Project No.: 9437-2B	Date: May 8, 1995	Owner: Nassau County, Florida
Project Name: Fernandina International Tradeplex Roadway Contractor: Walding Company

CHANGE ORDER

Project No.: 9437-2B	Date: October 17, 1995	Owner: Nassau County, Florida
Project Name: Fernandina International Tradeplex Roadway Contractor: Walding Company

Item 10 e.

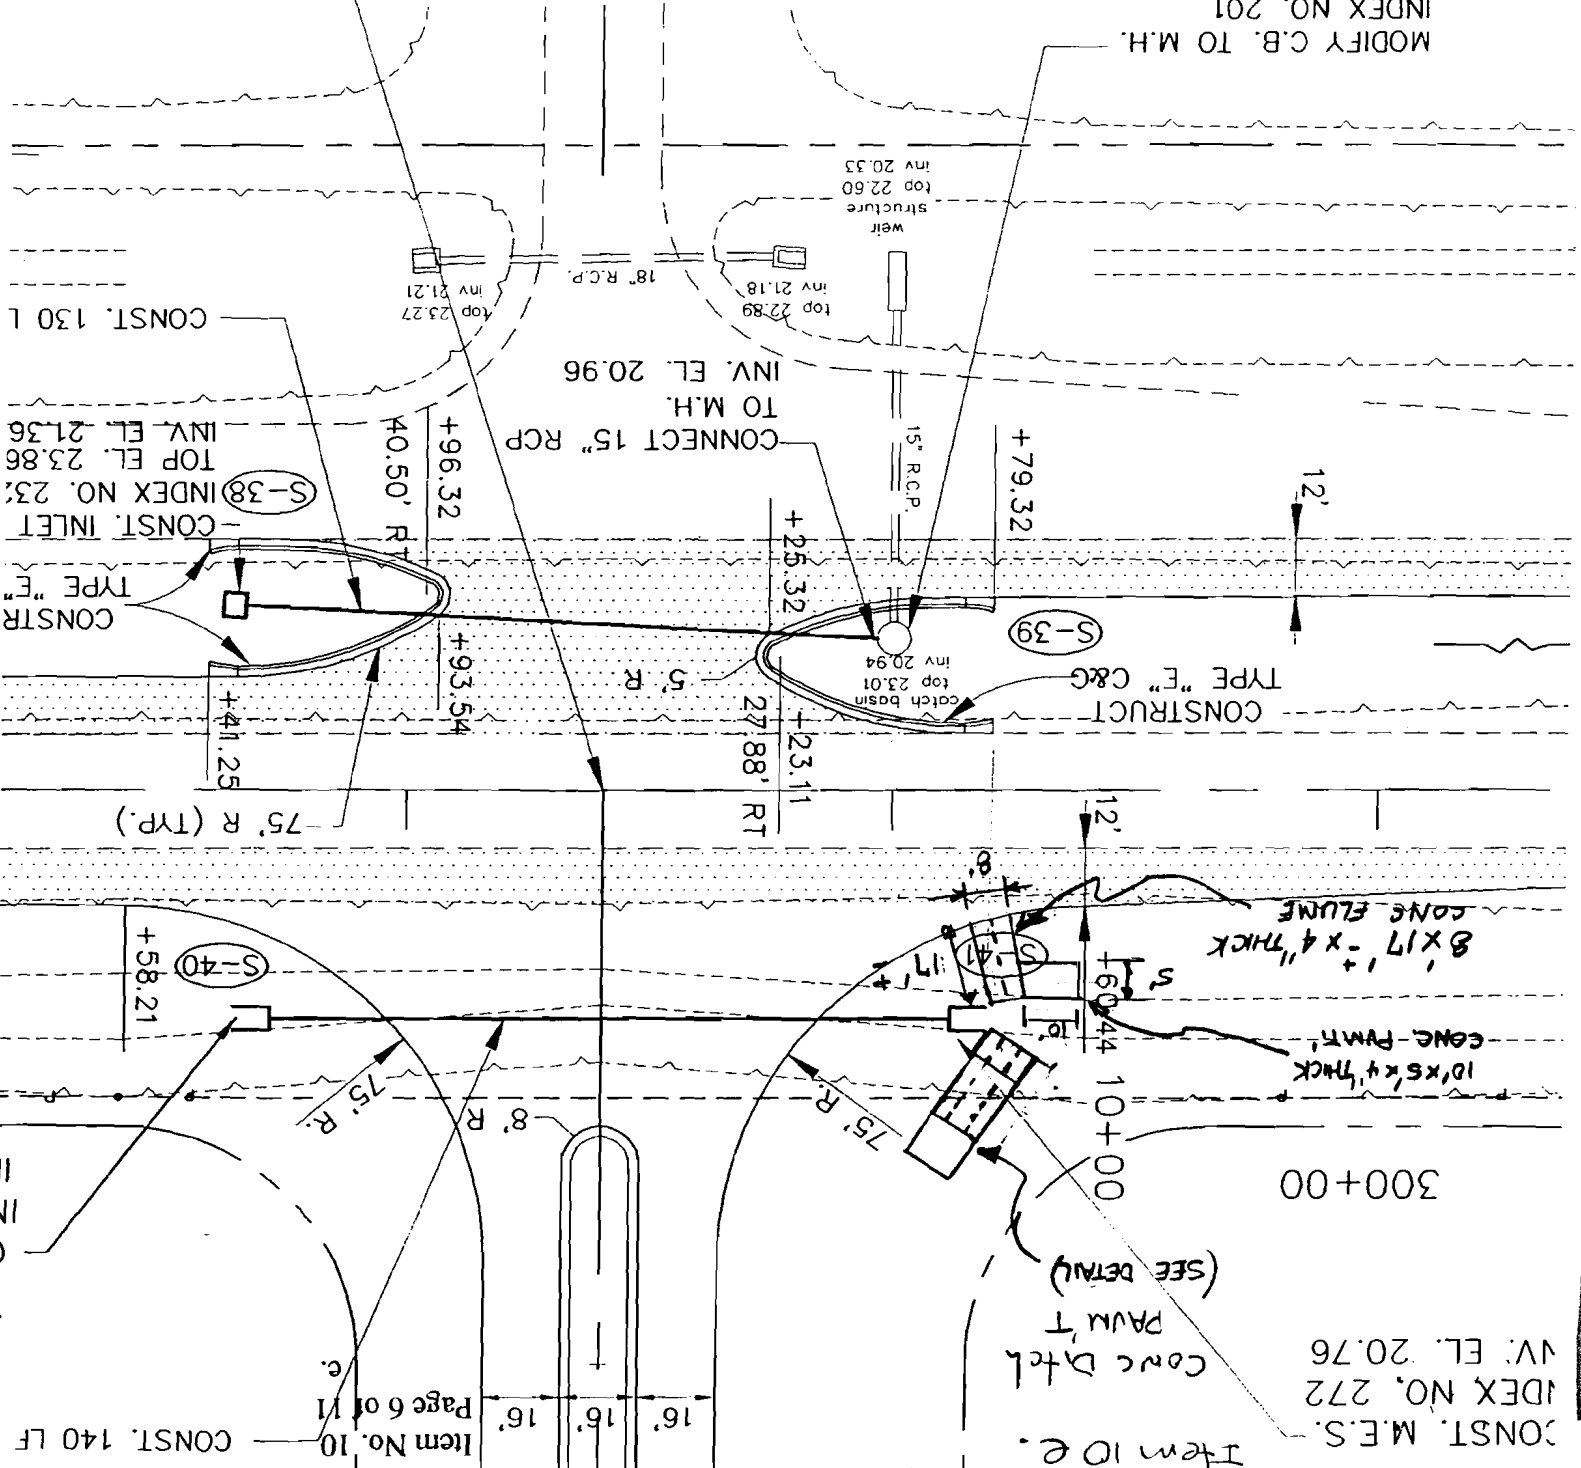
- d. Sod at headwall of 42" pipe per sketch.
- e. 4" thick concrete pavement and 4" thick concrete ditch pavement per sketch.
- f. Sod median area per sketch.
- g. Sod front area per sketch.
- h. Additional rubble riprap at weir per sketch.
- i. Sodding at cross culvert per sketch.
- j. Add concrete between headwalls per sketch.

10'x5'x4" THICK CONC. PAVMT

8'x17' x 4" THICK CONC. FLUME

ITEM No 10 h.

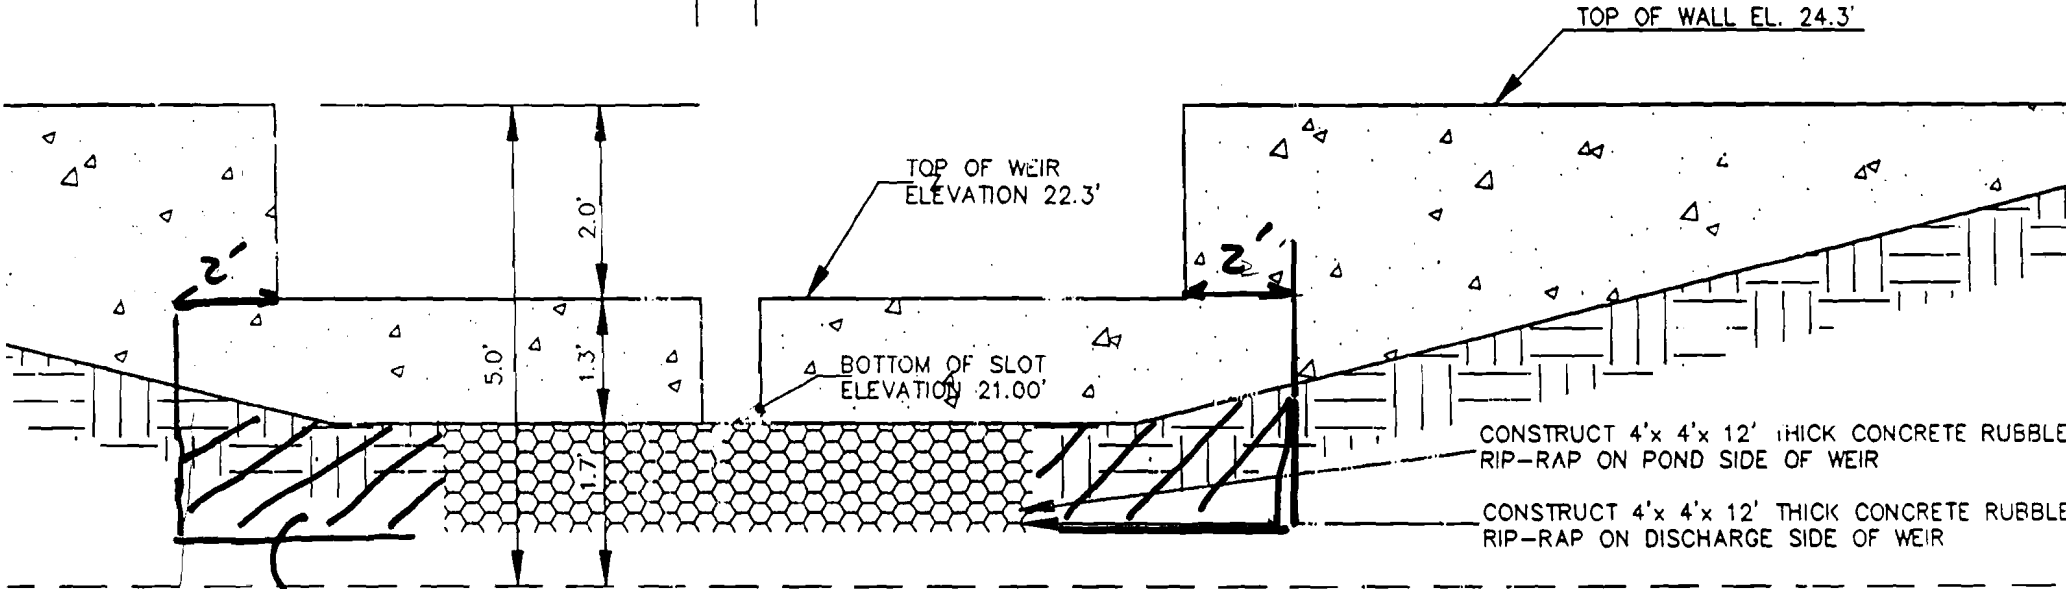
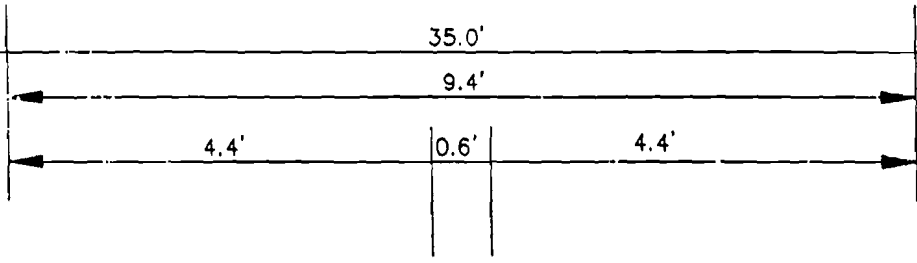
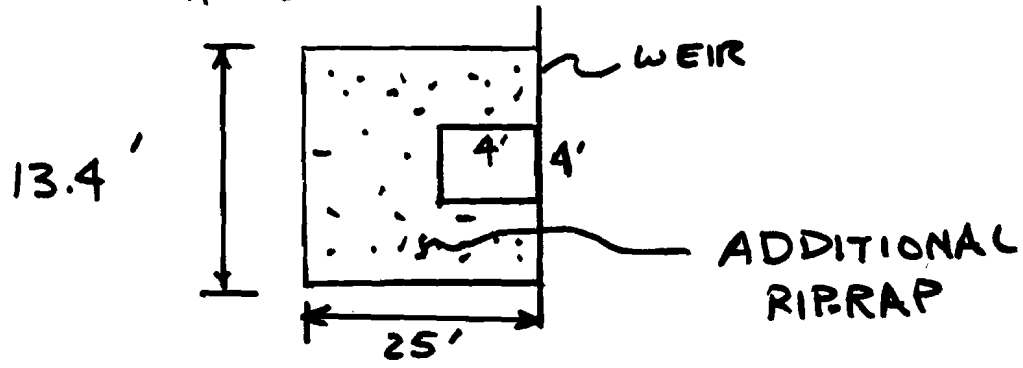
CONSTRUCT 4' x 4' x 12" THICK CONCRETE RUBBLE RIP-RAP ON POND SIDE OF WEIR
CONSTRUCT 4' x 4' x 12" THICK CONCRETE RUBBLE RIP-RAP ON DISCHARGE SIDE OF WEIR

ADDITIONAL CONC. RUBBLE RIP-RAP

ITEM 10 i.

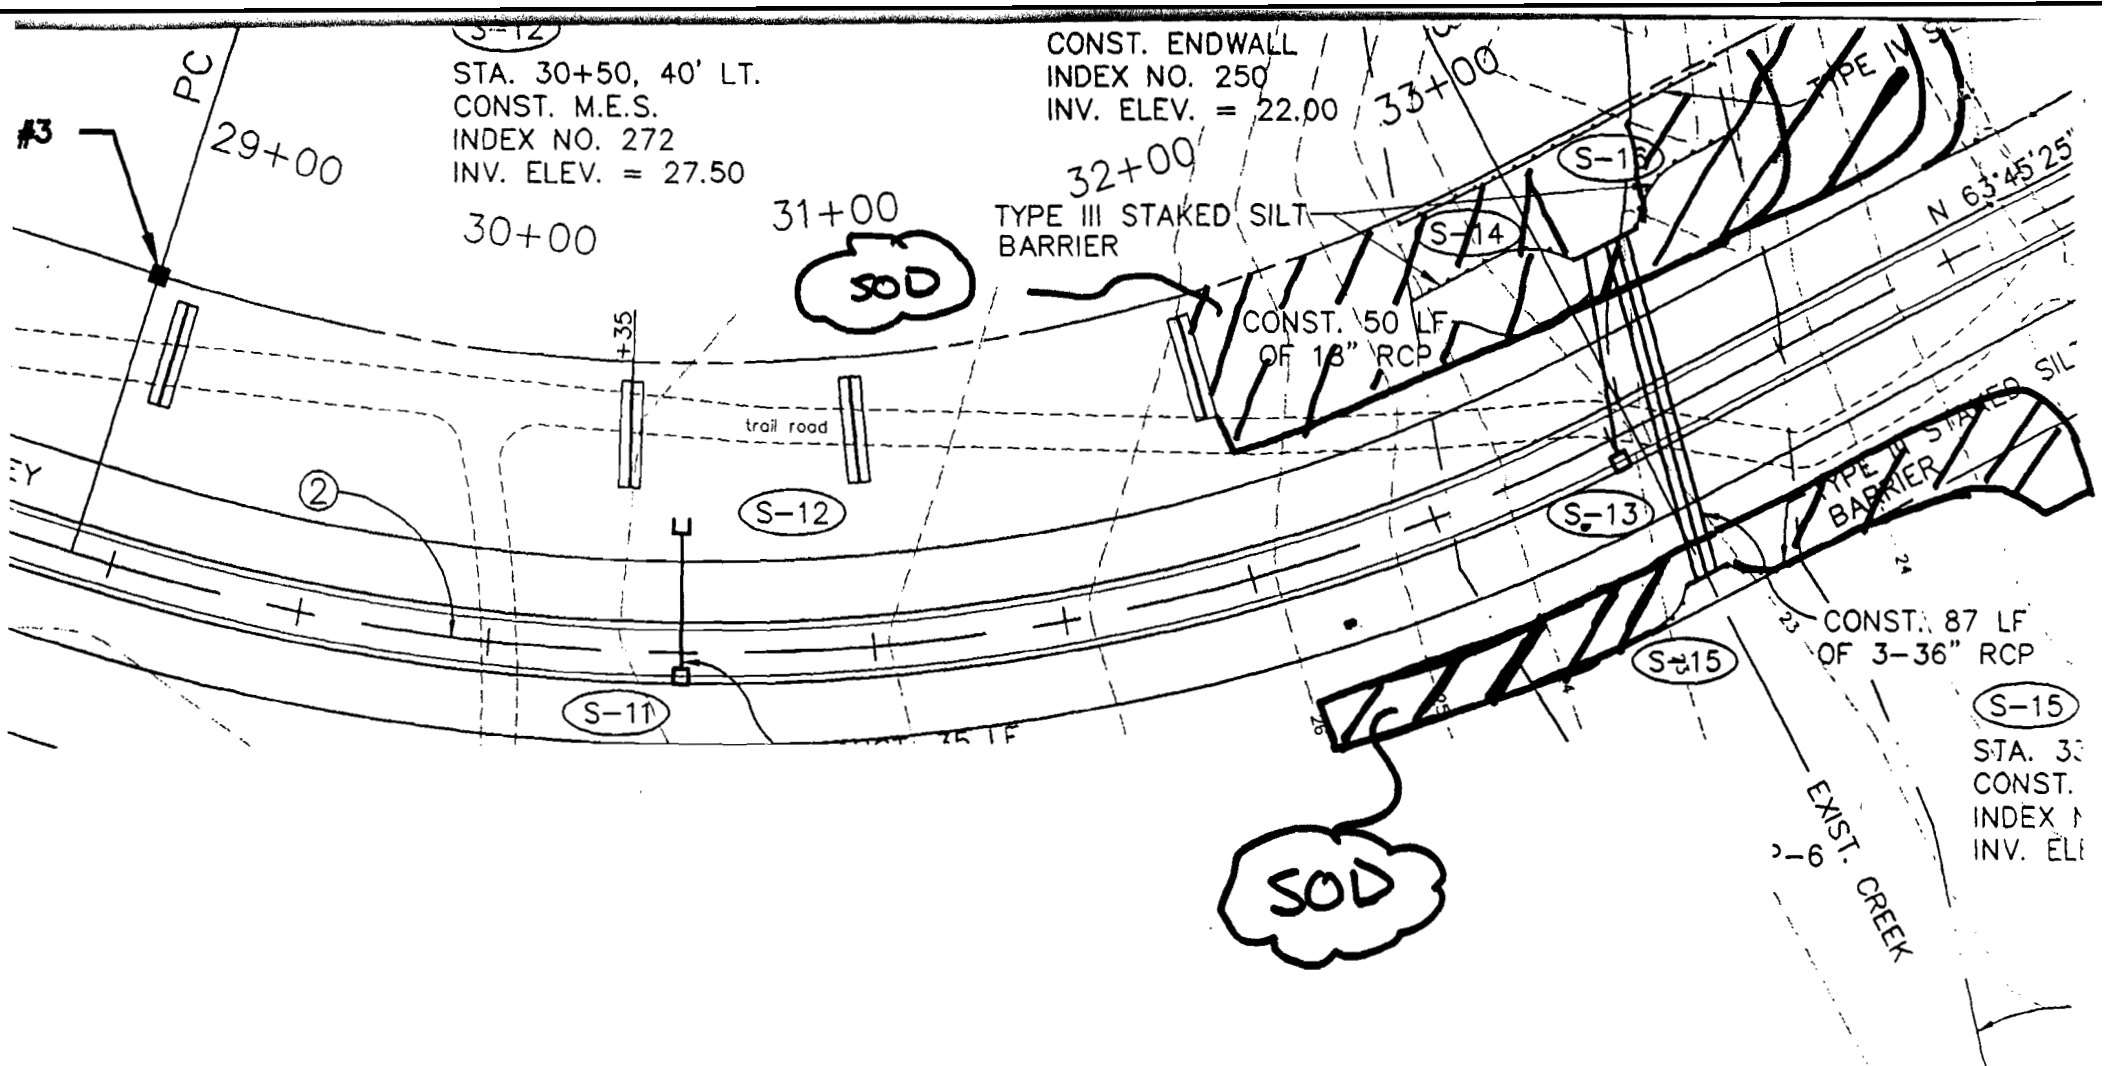
CONSTRUCT 2' x 12" THICK CONCRETE RUBBLE RIP-RAP ADJOINING EDGE OF EXISTING RIP-RAP ± 8' x DISTANCE TO TOE (APPROX. 25') x 12" THICK CONCRETE RUBBLE RIP-RAP ON DISCHARGE SIDE OF WEIR
